December 19, 2014

Re: SR 99: Shaft Excavation Status Report & Action Items for Discussion
TBM Access Shaft, Seattle, WA

Figure 2: East Shaft Wall Design In-Fill Areas (Solid Gray Shaded Areas)

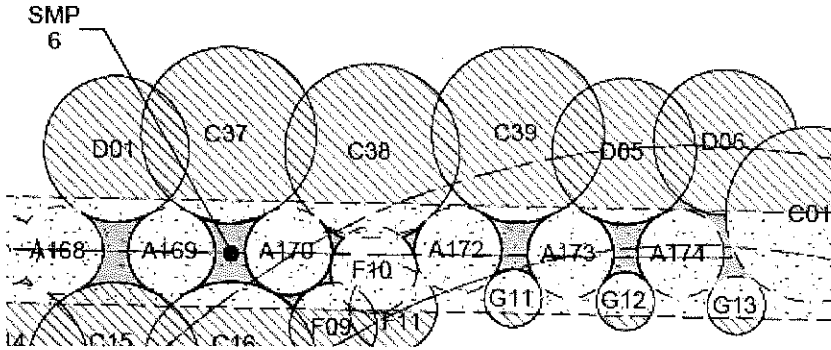
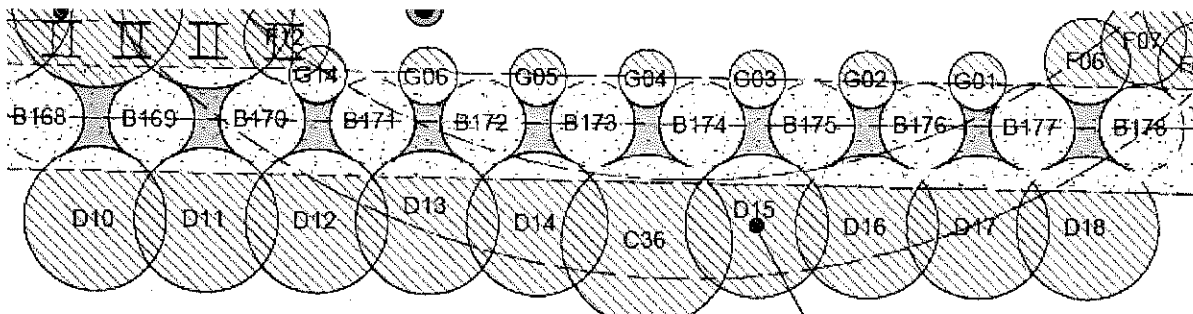
Reviewing the as-built locations of the shaft piles at regular vertical intervals, we are concerned that there is a potential for much larger untreated soil zones to exist that were not considered in the design, depending on the location of the SESMP piles. The design pile layouts shown in Figure 1 and Figure 2 indicate the originally expected in-fill or void areas in solid gray.

Figure 4: East Shaft Wall Pile As-built (Potential Void Areas Highlighted in Yellow or Hatched)

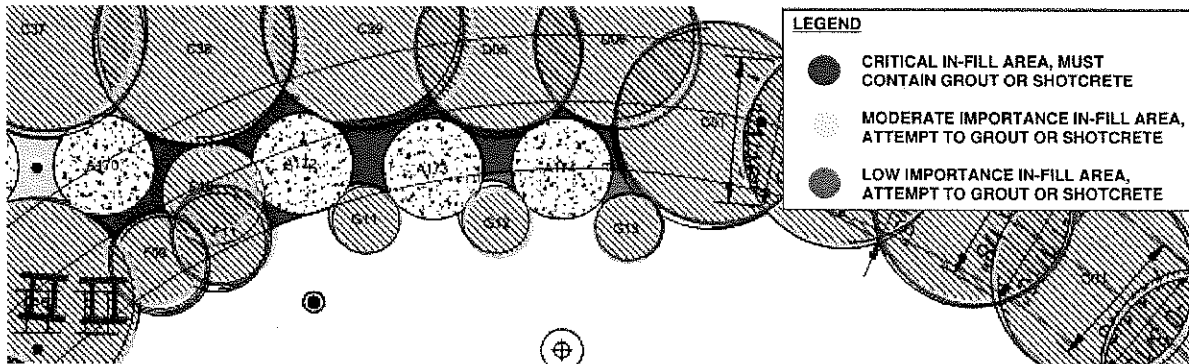
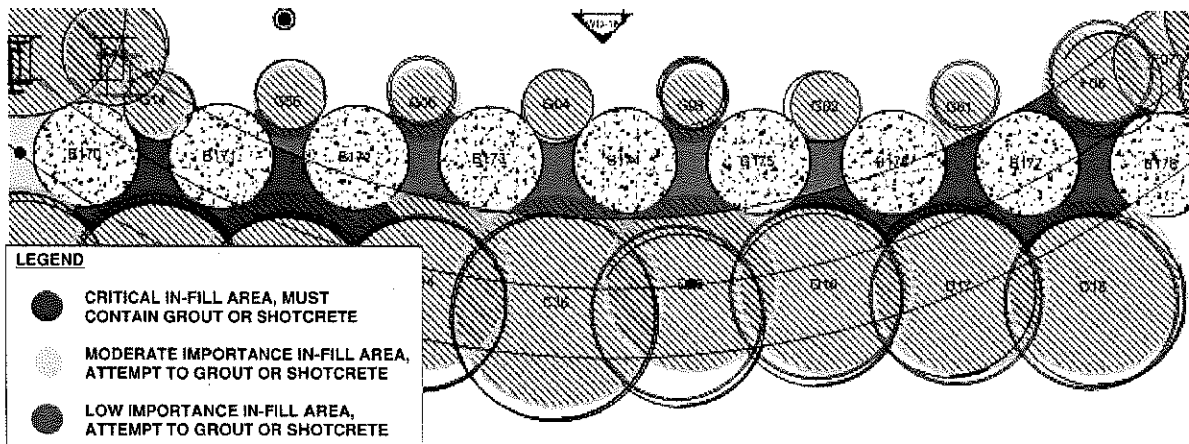
Upon review of the as-built secant pile locations with respect to the SESMP piles, there appears to be a potential for much larger in-fill areas than initially intended in the design. Given the observed untreated soil zones in the in-fill areas to date, the as-built pile layouts shown in Figure 3 and Figure 4 indicate the extent of potential untreated zones in the colored areas. Potentially untreated soil zones that fall within the theoretical design compression ring and may have a significant effect on the stability of the shaft structure are shaded red. A continuous compression ring of adequate thickness and strength is essential for the structural stability of the wall.

While it is likely the in-fill areas are larger than initially intended, we do not believe they are as extensive as shown in the as-built pile layouts of Figure 3 and Figure 4. For example, Figure 4 shows the potential for a nearly continuous void through the entire width of the shaft wall between piles B177/F06 and B178/D18. However, if this were the case, we believe that significant seepage and ground loss would have been observed during the course of excavation to date. Given the rate of seepage observed and the lack of ground loss outside the shaft, it is likely there is some continuous wall present between piles B177/F06 and B178/D18.

The source of the uncertainty for the as-built condition is the lack of as-built data for the SESMP piles. Once the as-built of the SESMP piles is incorporated into the existing overall shaft as-built drawings, a more refined analysis of the ring-structure can be completed and critical in-fill repair locations identified.

Given the uncertainty of the SESMP pile locations and the extent of the corresponding in-fill area, we recommend removing piles G01, G02, G06, G11 and G12 to better provide access to the in-fill areas and to obtain a clear SESMP pile as-built. We understand that STP's subcontractor NCM will be submitting a plan for our review and comment.
